MARVEL - SCHEBLER PRODUCTS DIVISION

SERVICE BULLETIN

#A2-66

SUBJECT: REMOVAL OF THE THROTTLE OPENING SPRING FROM A10-3965-12, A10-4115-1
AND A10-4439 CARBURETORS

CARBURETORS A10-4115-1 AND A10-4439

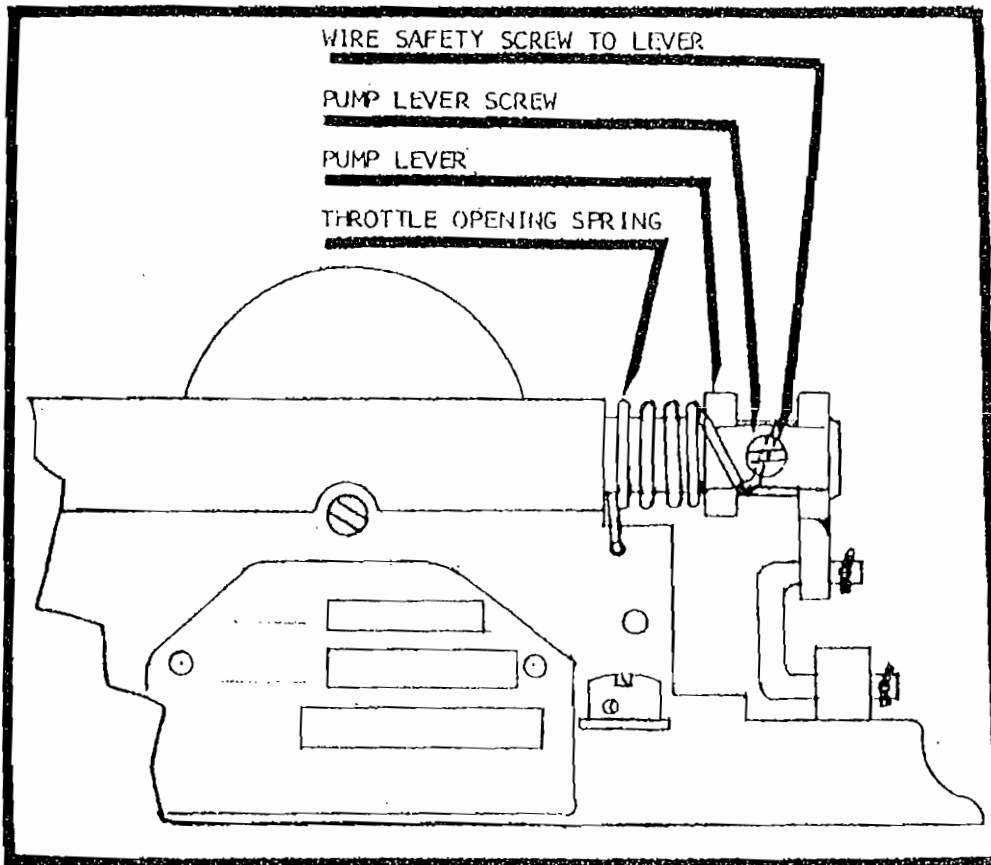
THESE CARBURETORS ARE IDENTICAL EXCEPT FOR SUBJECT SPRING, WHICH IS
LOCATED ON THE END OF THE THROTTLE SHAFT OPPOSITE FROM THE THROTTLE LEVER END.

THE CARBURETORS ARE INTERCHANGEABLE WHEN THE SPRING IS REMOVED.

THE THROTTLE OPENING SPRING ON THE A10-4115-1 AND A10-4439 IS ALSO USED TO SAFETY THE PUMP LEVER RETAINING SCREW.

THEREFORE, IF YOU REMOVE THE SPRING, IT WILL BE NECESSARY TO SAFETY WIRE THE PUMP LEVER RETAINING SCREW TO THE PUMP LEVER. SEE ILLUSTRATION BELOW:
